Title			ISC System Wiring Diagram		
Size	Number			Revision	
B	D1900511			V5	
Date:	2/25/2021	Sheet	1 of 38		
File:	C:\Users\...\ISC_C1_SH1.SchDoc	Drawn By:	Filiberto Clara

ISC System Wiring Diagram

ISC-R1 Rack

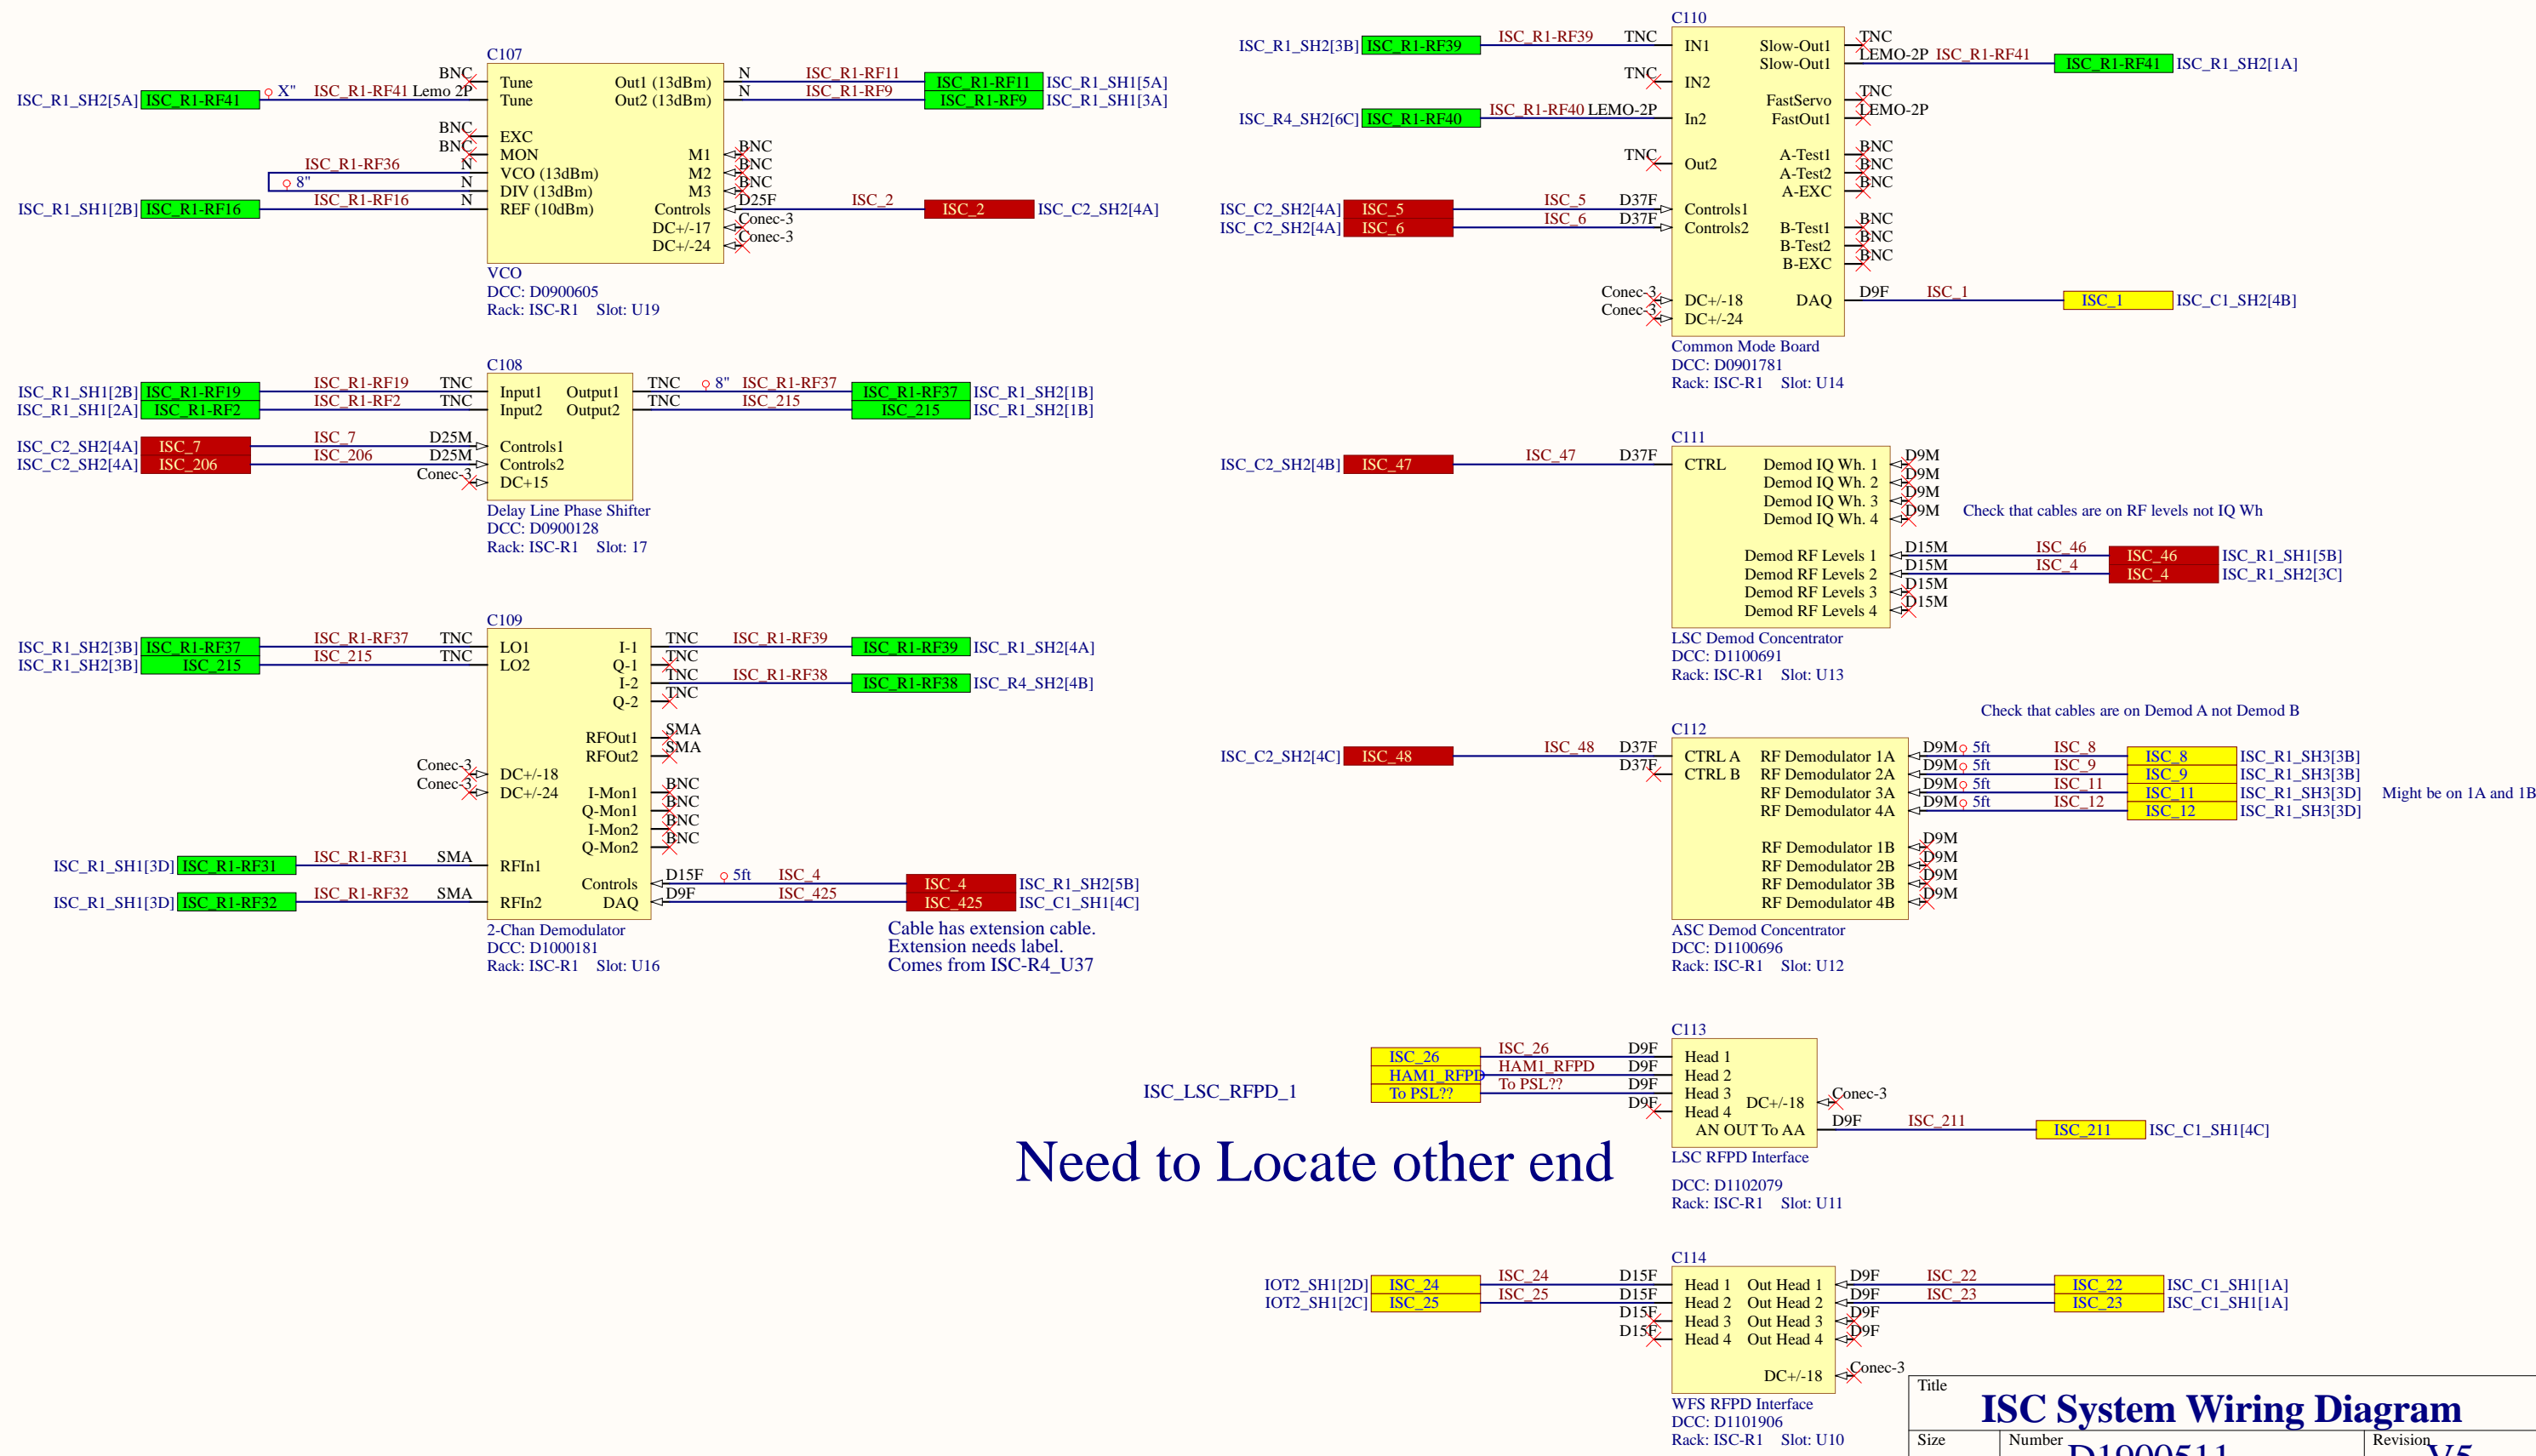
Need to Locate other end

ISC-R1 Rack

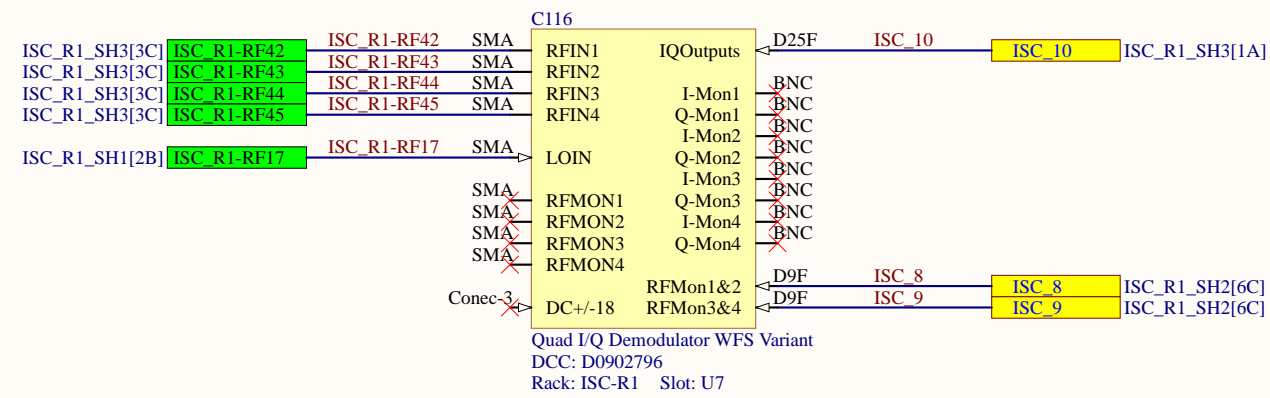
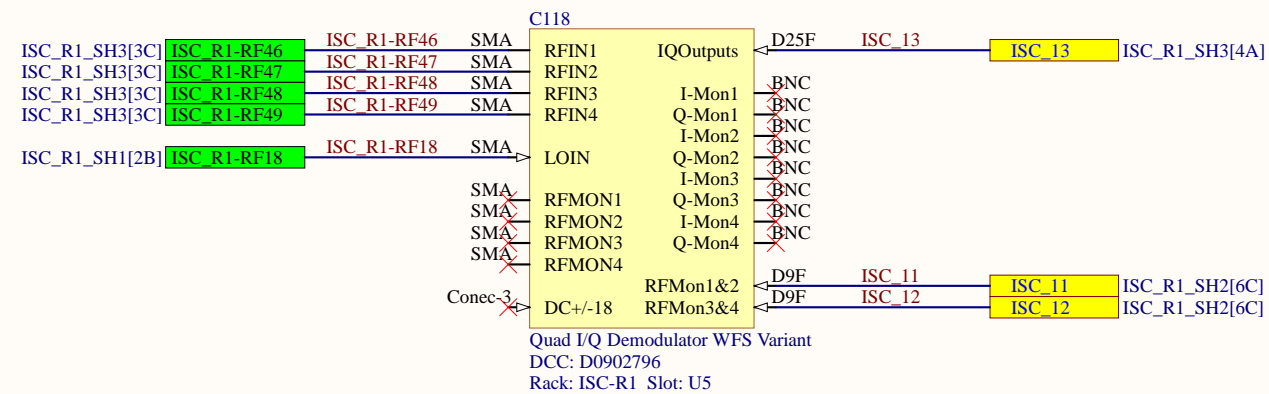
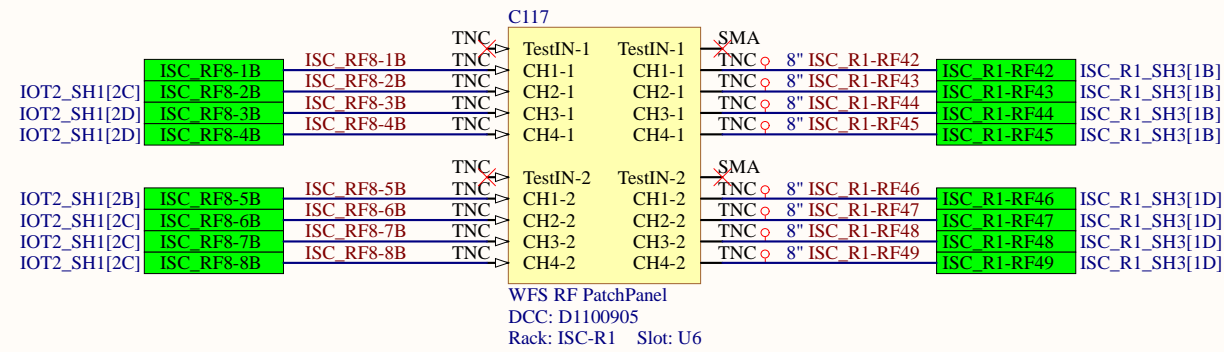
Need to locate other end

434/435 already used
ASC-POP_X_PIT/YAW

ISC-R4 Rack

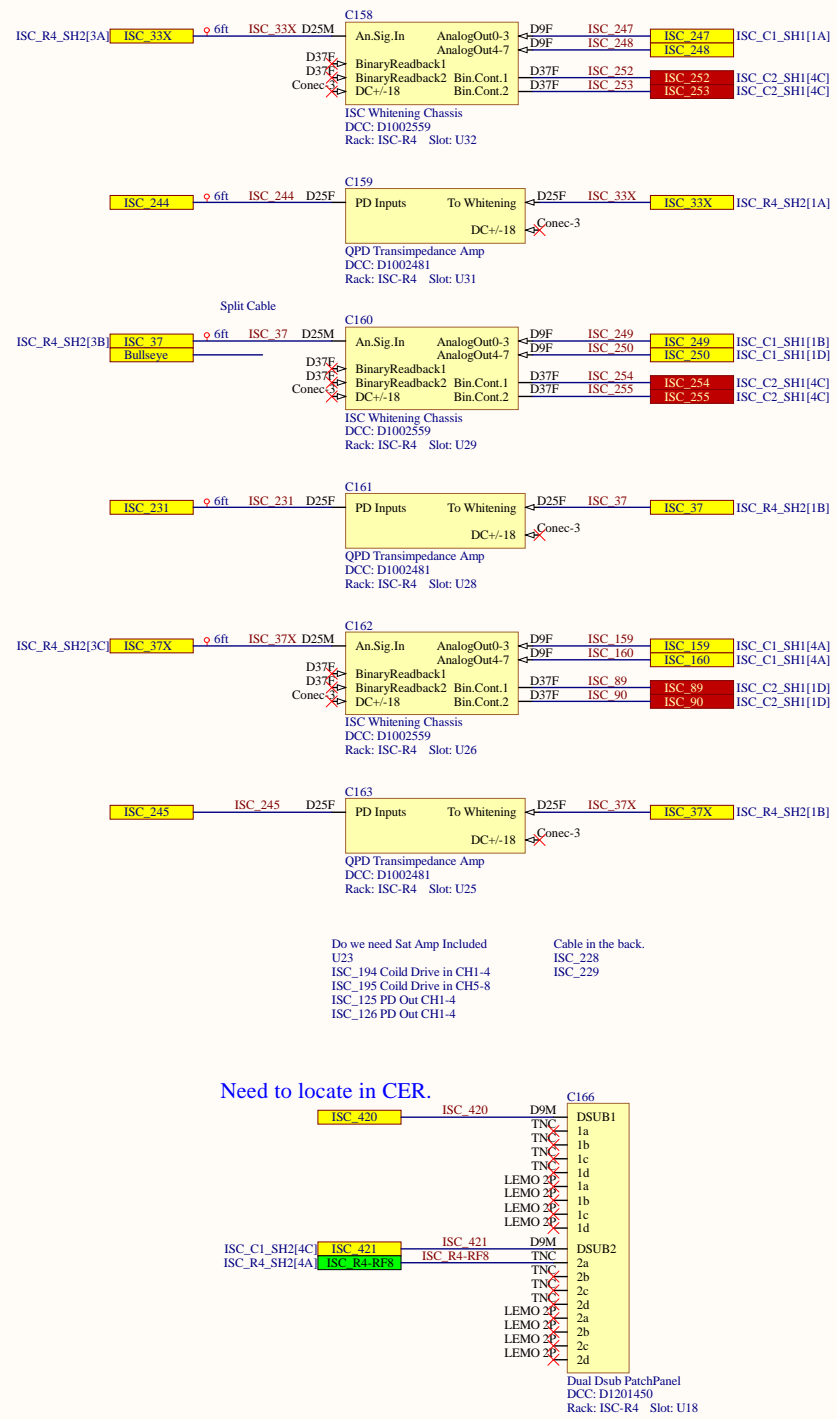
Otherside not labeled. RED
Otherside not labeled. Green
Otherside not labeled. R4 ISC1
Otherside not labeled. R4 ISC2
Otherside not labeled. Old label H1_ALS_PSL_PD1

ISC-R3 Rack

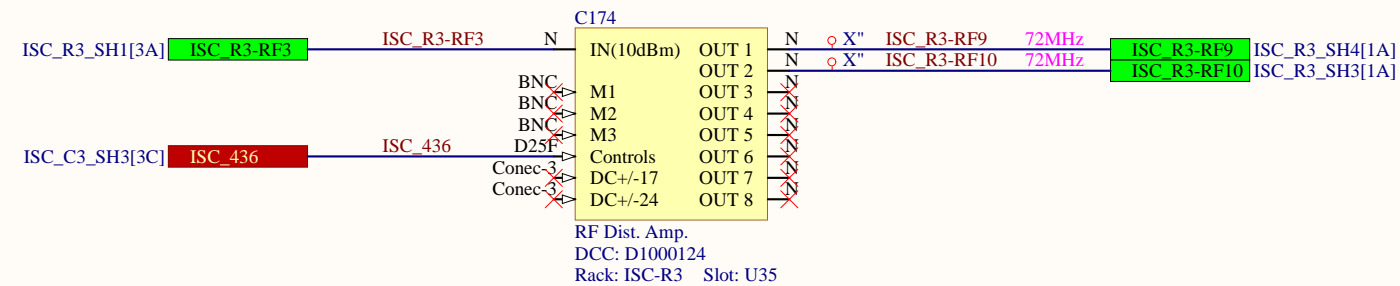
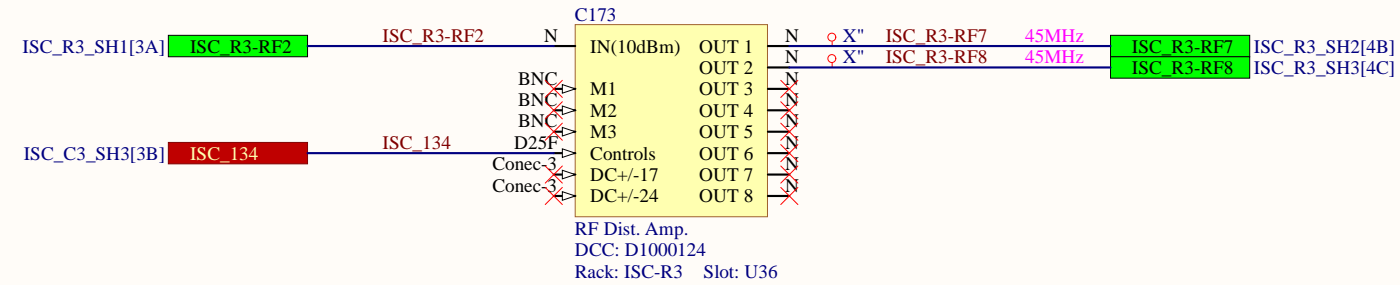
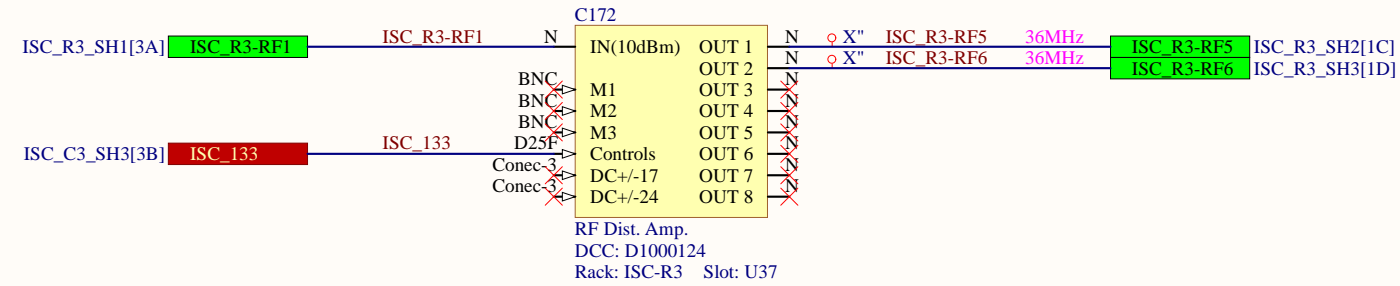
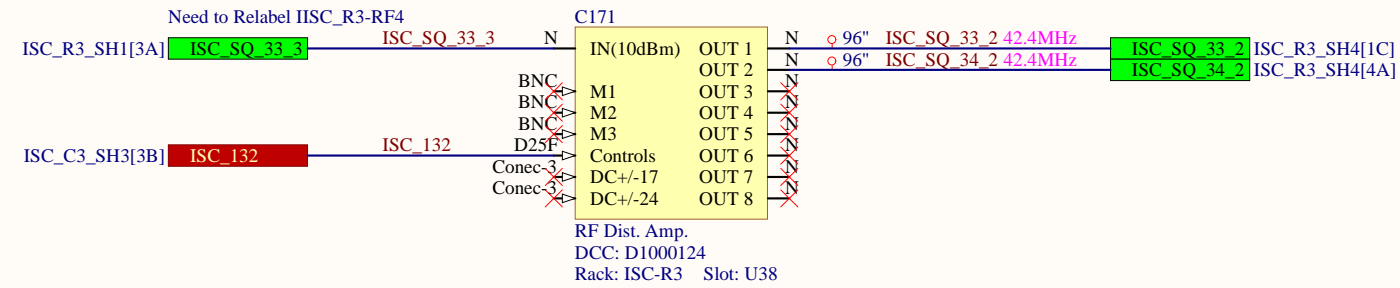
Need to Relabel ISC_R3-RF4

ISC-R3 Rack

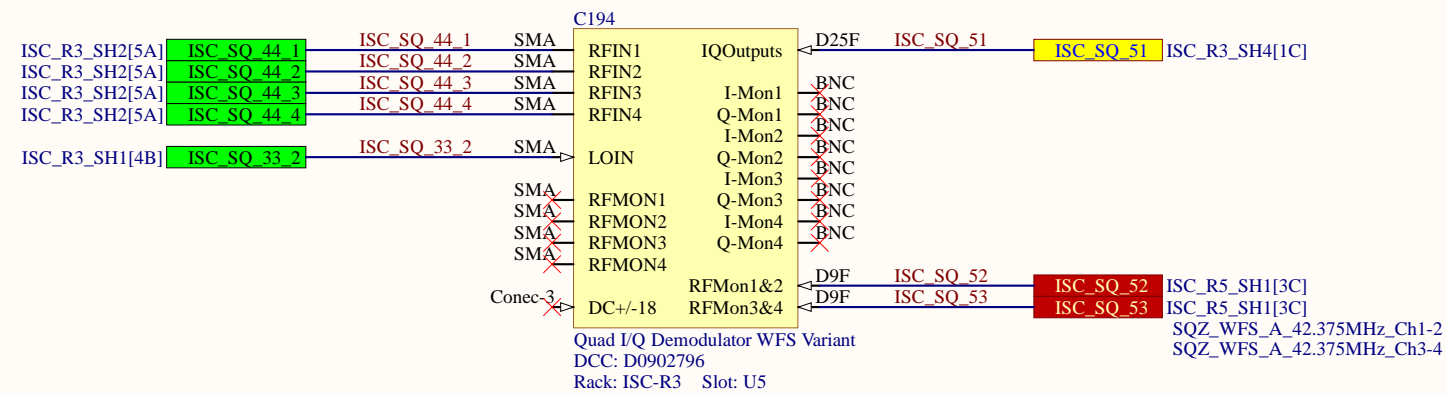
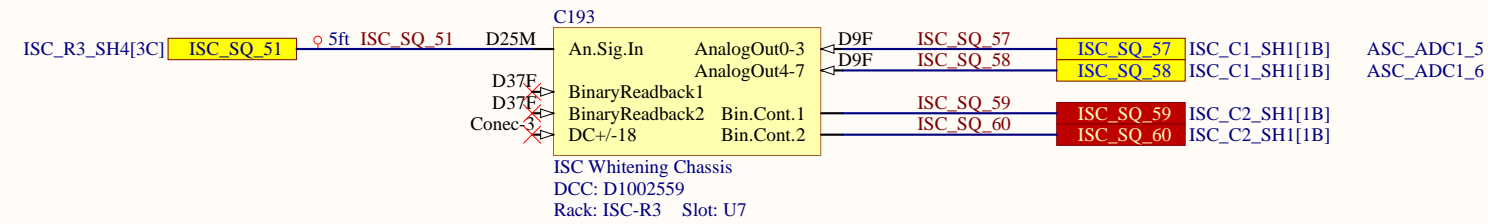
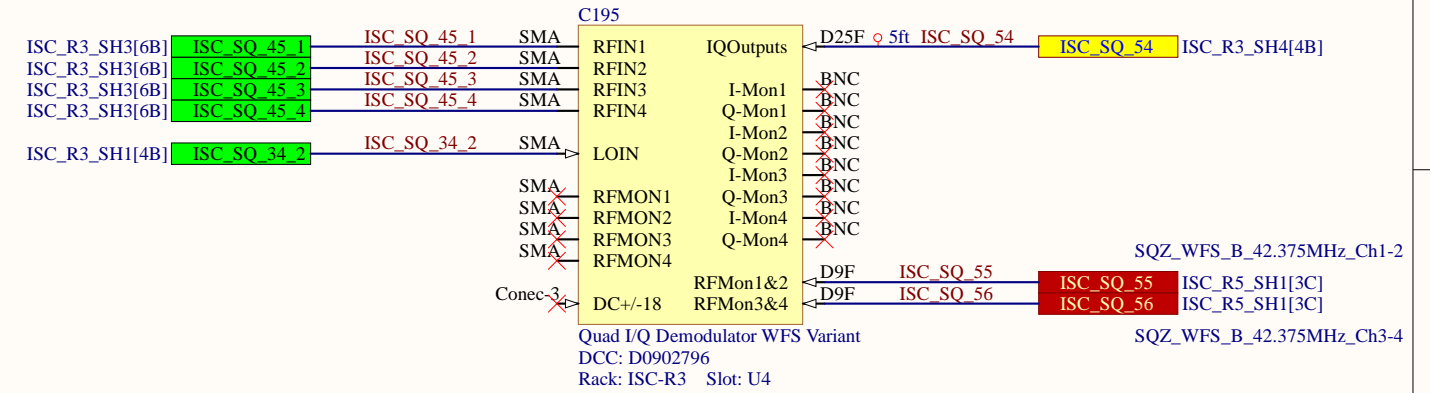
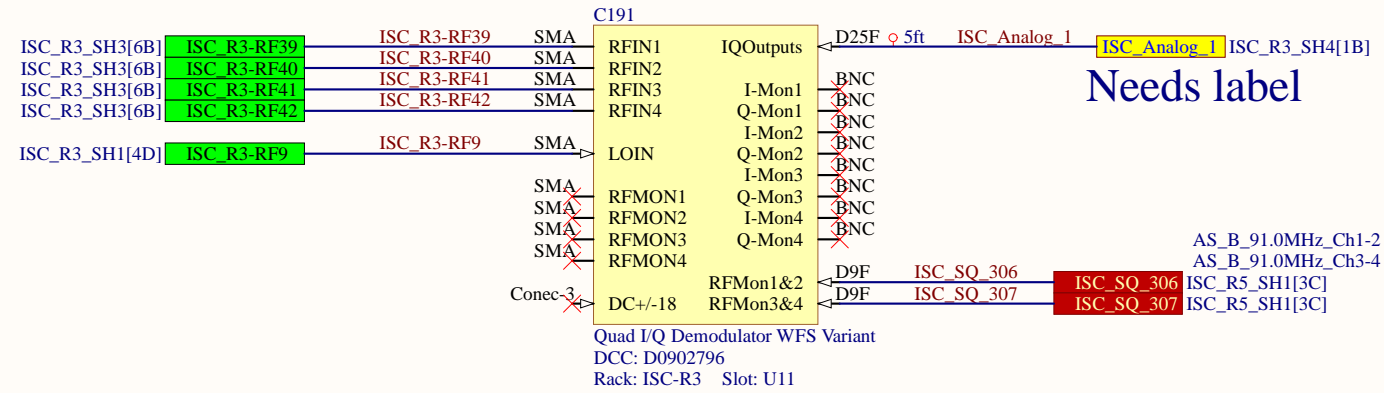
Needs labels

Needs label
